Appendix B2
Clondalkin to
Drimnagh
– 1st Non-Statutory
Public Consultation
Submission Report

Corridor 8 – Clondalkin to Drimnagh

Emerging Preferred Route – Public Consultation Report 2018/2019

Section 1: Nangor Road

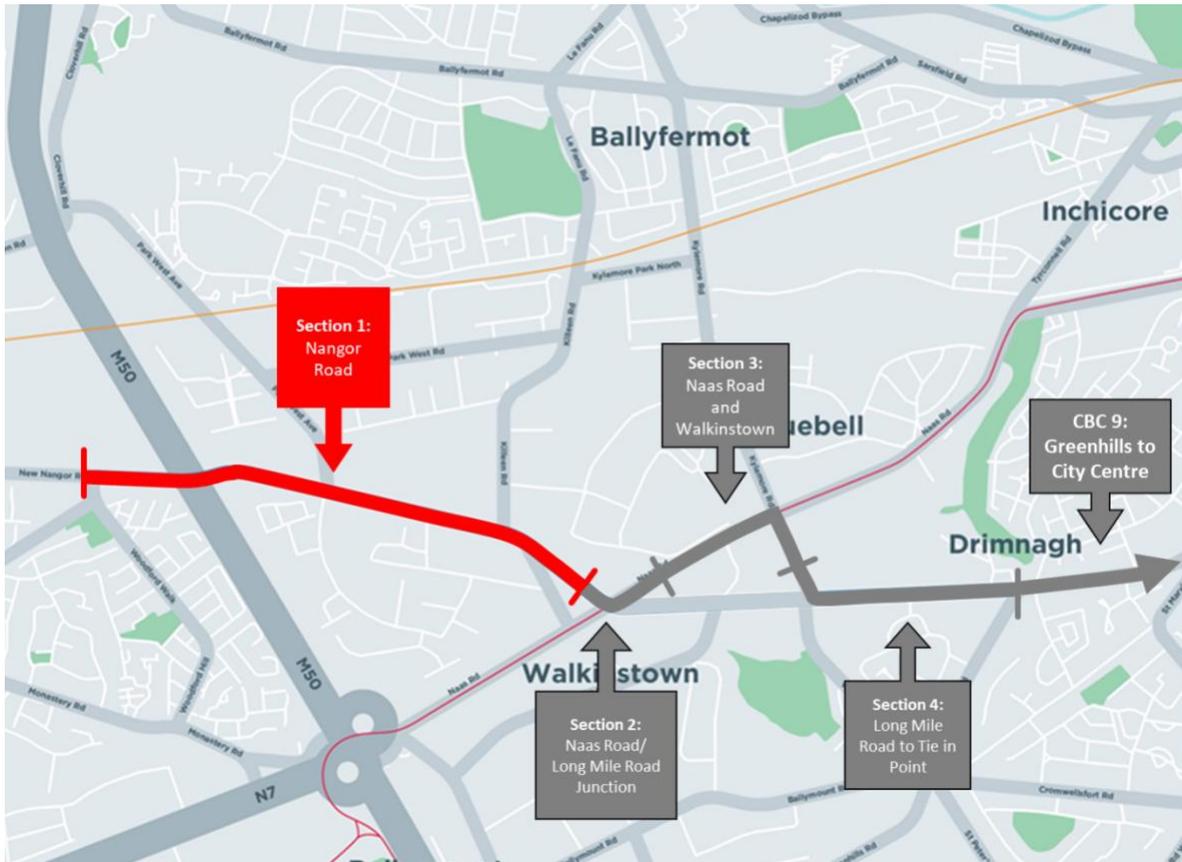
- The inclusion of shared spaces along Nangor Road is not welcomed by the public. Shared surfaces provide a low level of service for all users.
- Segregation for cyclists and pedestrians is crucial along Nangor Road in order to increase the attractiveness of active travel modes and the use of public transport.

- No segregation for motorists and cyclists at Woodford Walk Junction. Counter intuitive to segregate all along the route and then mix at junctions where they are most vulnerable.
- Bus stop bypasses have proven dangerous for pedestrians, particularly vulnerable pedestrians with disabilities. Reports from transport authorities in Copenhagen have proven this.
- Remove left turn slip lane.

- Provide bus stop bypasses (island bus stops) at all stops (Requested by Cycle Groups).
- In line bus stops are unacceptable and have proved to increased accidents by 1900% in Copenhagen.
- Proposal to change existing roundabout on Nangor Road / Riverview Business Centre entrance will be abused as cyclists stay on the path and use crossings with pedestrians.
- Shared space on the corner of Nangor Road/ Park West Avenue not appropriate and unsafe for pedestrians.
- Fully segregate cyclists at Business Centre entrances and provide buffer space turns to avoid HGV blind spots. Consider raised cycle tracks at junctions to allow priority for cyclists.
- All arms of the Oak Road/ Nangor Road/ Park West Avenue junction are secondary GDA CNP routes. It should be safe for cyclists to travel in all directions, so a fully segregated junction should be provided for here.
- Remove slip lanes.

- Is there a buffer separation between pedestrians and cyclists?
- Given that there is sufficient space provided at the Diageo Entrance on Nangor Road, a buffer space priority junction for cyclists should be considered.
- Irish Soft Drinks Ltd. Property backs onto Nangor Road at Map 4. Owner is not sure if the council ever purchased the land that currently Nangor Road runs on. There are existing drains that run under the property.

- The junction at Willow Road/Nangor Road doesn't provide proper segregation of motor traffic and bicycle traffic.
- Provide bus stop bypasses (island bus stops) at all stops.
- Four drive through bus stops all unacceptable from a safety position for all pedestrians and cyclists.

- Shared surfaces at pedestrian crossing at Killeen Road/ Nangor Road junction not welcomed.
- Sufficient space at outbound bus stop to provide a bypass for cyclists.
- Shared space at crossing will create a 'kill zone' for pedestrians.
- Remove slip lanes.
- Segregating cyclists from left-turning traffic needs to be strongly considered here.

Section 2: Naas Road/ Long Mile Road Junction

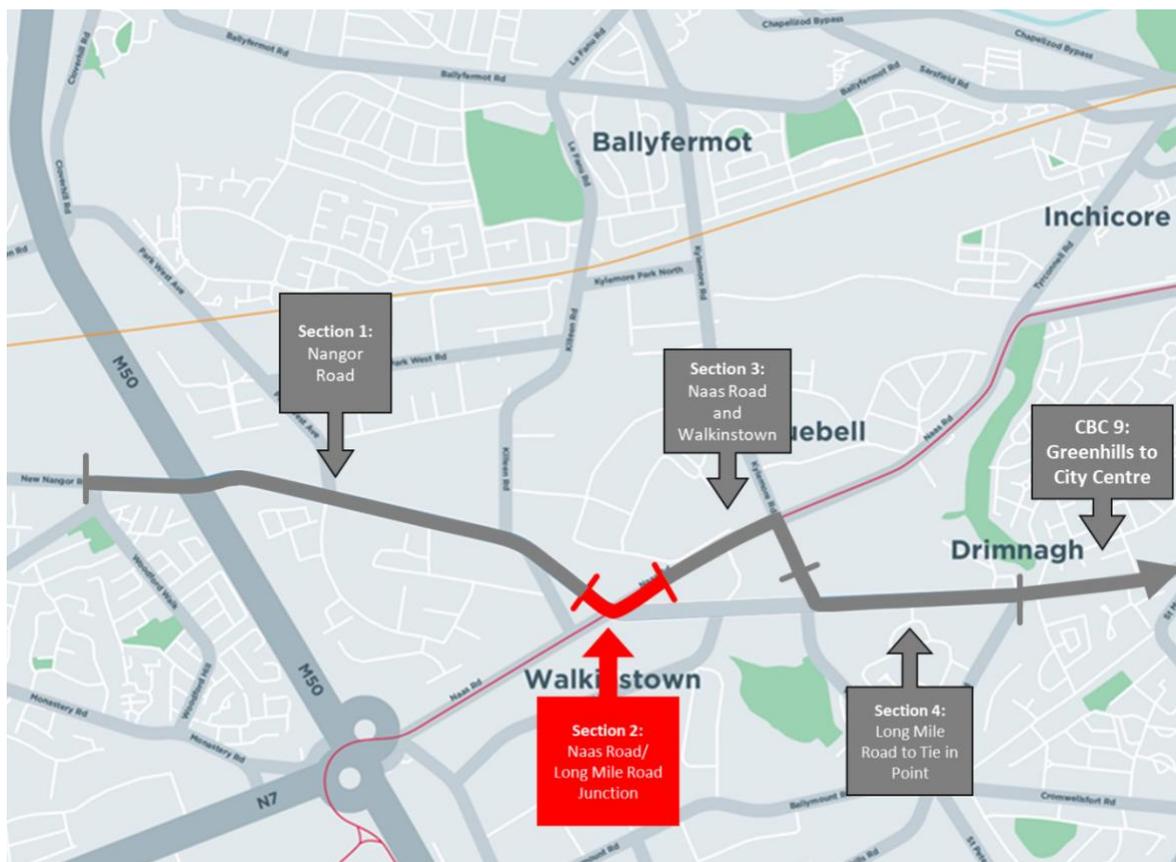
- Consider a Dutch-Style Junction with segregation provided for all road users.
- Toucan crossings are not safe for pedestrians, cyclists cross at speed, and refuse to dismount.
- Dublin Cycling Campaign refers to this junction as “a beast of a junction for cyclists”. A two-way cycle track will significantly reduce the number of crossings required for a cyclist.
- Install a buffer zone of 0.5 – 1m between two-way cycle track and carriageway on both sides of the road.
- Maps show that it takes 6 Toucan Crossings to cycle southbound into the junction and wish to cycle westwards.

Section 3: Naas Road and Walkinstown Avenue

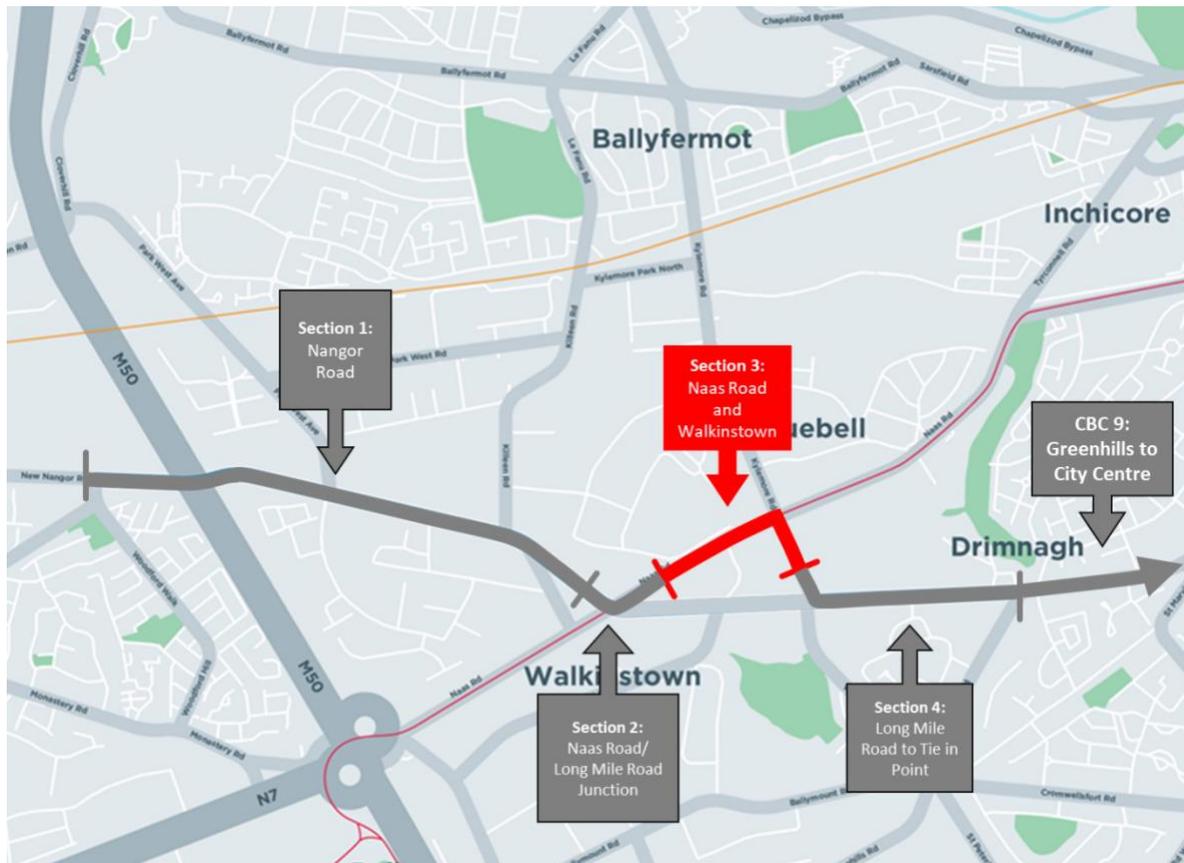
- Shared surfaces at pedestrian crossing at each junction are not welcomed.
- Inline bus stops are not adequate design for cyclists.
- Install a buffer zone of 0.5 – 1m between two-way cycle track and carriageway on both sides of the road.
- Consider reducing the road lane widths to 3m to allow for a 0.5m buffer space between cycle lane and road on both Long Mile Road and Walkinstown Avenue.

- Shared surfaces at pedestrian crossing onto John F. Kennedy Drive not welcomed.
- Island bus stops are both too small and badly designed with poor tactile information. There is no method implemented to slow cyclists before the bus stop.
- Provide a raised table to avoid HGV blind zones at Harris Warehouse entrance.
- Install a buffer zone of 0.5 – 1m between two-way cycle track and carriageway on both sides of the road.

- Shared surfaces at pedestrian crossing at Naas Road/ Walkinstown Avenue Junction not welcomed.
- Provide for bus stop bypasses at all bus stops, where there is ample space available.
- Kylemore Luas Stop: Add bike parking to facilitate multi-modal transport use.
- Proposed changes to the Walkinstown Avenue Junction include the provision of a right turn from the existing bus lane on Naas Road onto Walkinstown Avenue. The complexity of the signalisation and the interface with Luas operations through the junction has the potential to negatively impact Luas safety and efficiency.

Section 4: Long Mile Road to Tie in Point with Greenhills to City Centre Route

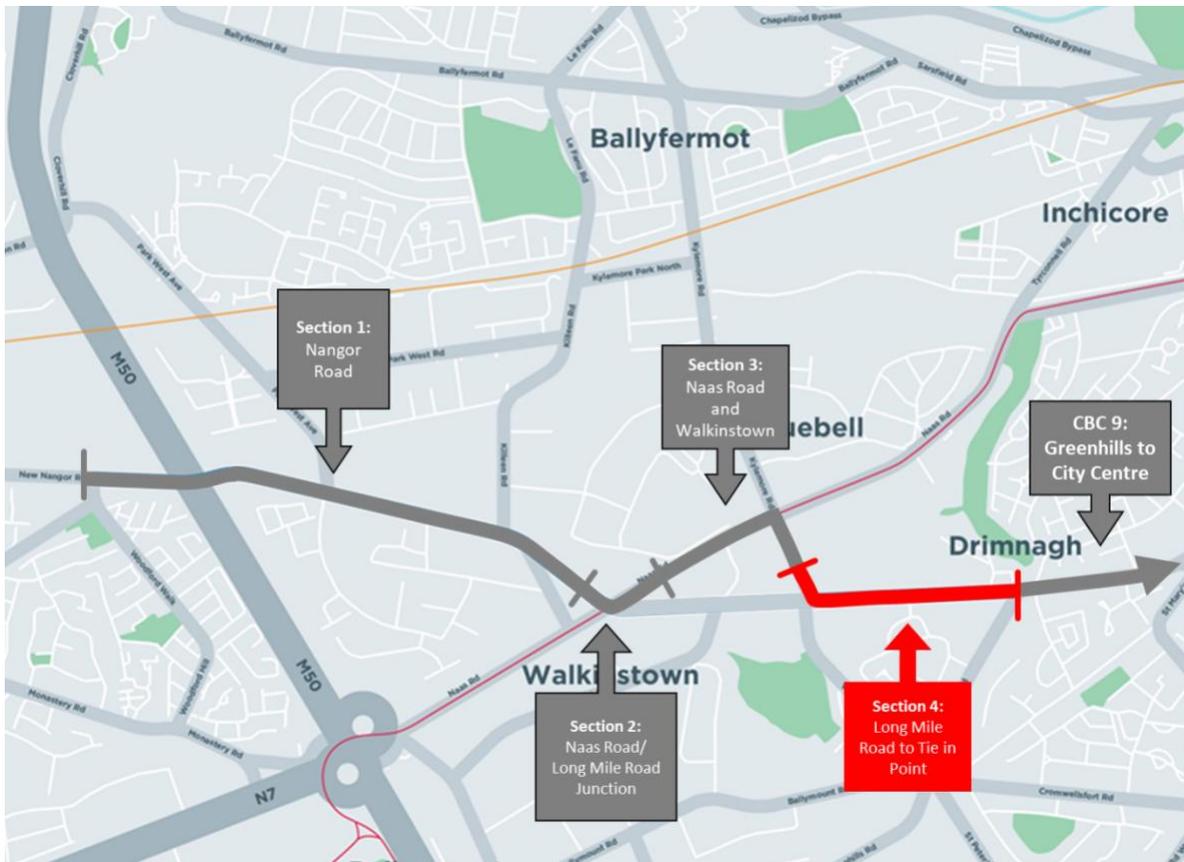
- Consider reducing the lane width to 3.5m to allow for a 0.5m buffer space between cycle lane and road on both Long Mile Road and Walkinstown Avenue.

- Shared surfaces at pedestrian crossing at Long Mile Road/ Walkinstown Avenue Junction not welcomed.
- Provide for bus stop bypasses at all bus stops, where there is ample space available.

- Walkinstown Parade/ Long Mile Road Junction doesn't provide proper segregation of motor traffic and bicycle traffic.
- Provide bus stop bypasses for cyclists where there is sufficient space (Long Mile Road).
- Remove Toucan crossing here, will only cause hazards for pedestrians crossing as they mix with fast approaching traffic.

- All junctions on this map do not provide proper segregation of motor traffic and bicycle traffic.
- Bus stop bypasses should be provided where there is sufficient space.
- Inbound bus stop lengthened which may cause problems for buses turning onto Long Mile Road to get parallel to the stop for ramp access.
- Major issue with parking on footpaths outside houses 133 – 147.
- Inbound bus stop has been lengthened which may cause problems for buses turning onto Long Mile Road to get parallel to the stop for ramp access.
